Huntlee New Town Stage 1A (MP 07_0116) and 1B (MP 08-0229) Project Applications

We refer to comments received from the *Department of Water and Energy (DWE)* concerning the above major project, in a letter dated the 23rd December, 2008. This letter responds to the comments provided in DWE's letter. As requested by DWE, further information is presented to detail the proposed treatment of riparian corridors in the Stage 1 Project Application Area.

FIGURE 1

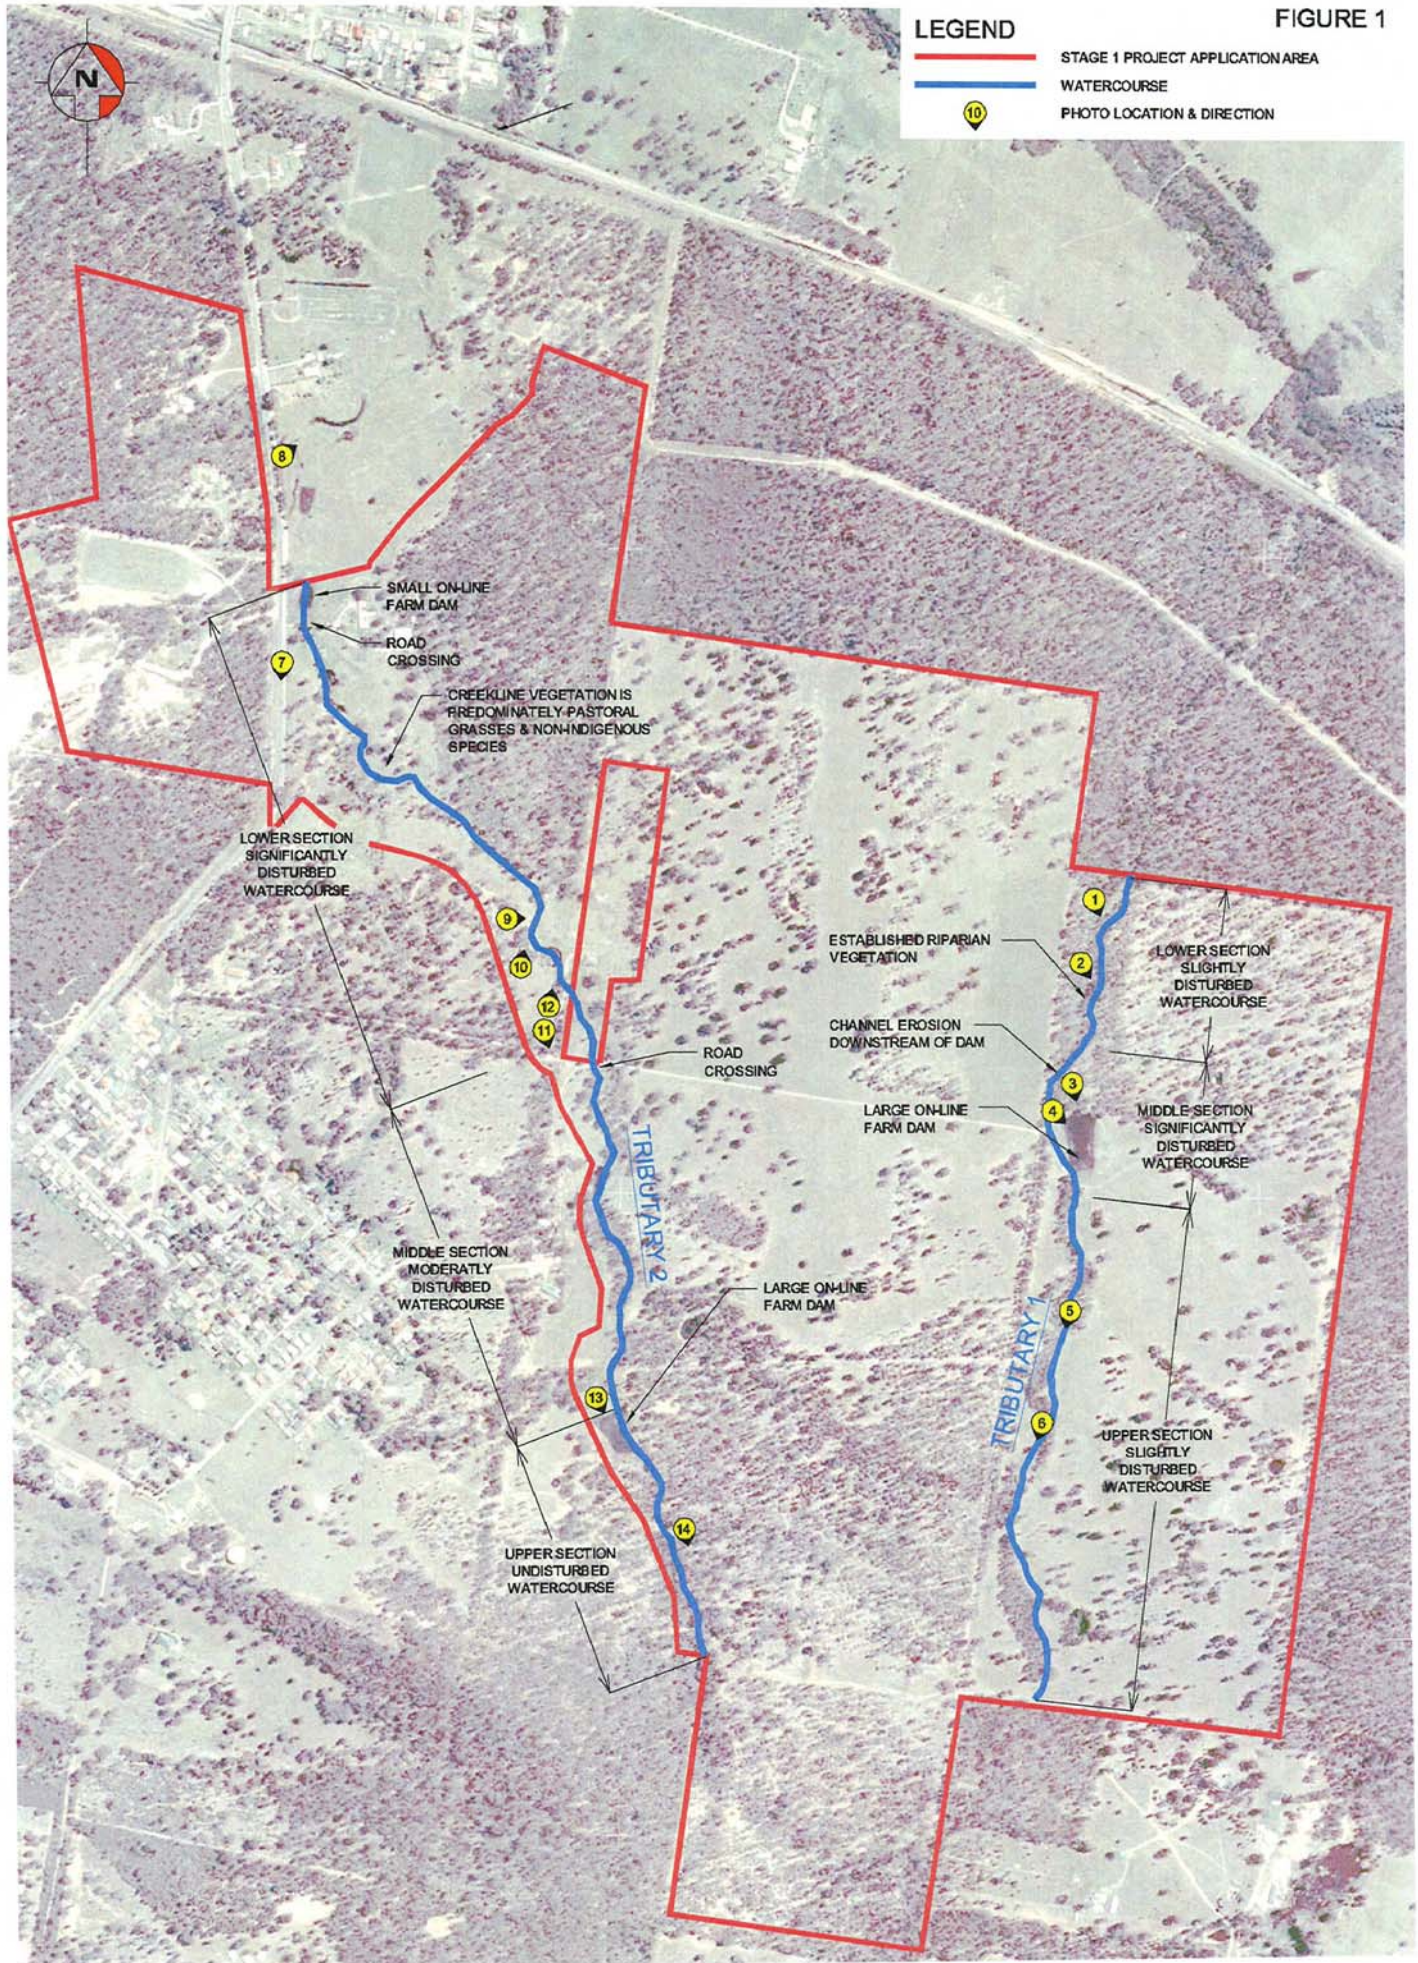
The following discussion should be read in conjunction with **Figures 1 and 2**, which details the locations of the photographs and provides general notes to support the following discussion.

In summary, the upper and lower sections of Tributary 1 would be described as a slightly disturbed watercourse. The middle section, which includes an online farm dam and the section of eroded channel immediately downstream of the dam, would be described as significantly disturbed.

In summary, the lower section of Tributary 2 would be described as significantly disturbed, the middle section as moderately disturbed and the upper section is undisturbed.

Each section of watercourse was described as either significantly disturbed, moderately disturbed, slightly disturbed or un-disturbed. The results of this assessment are summarised in **Figures 1 and 2**.
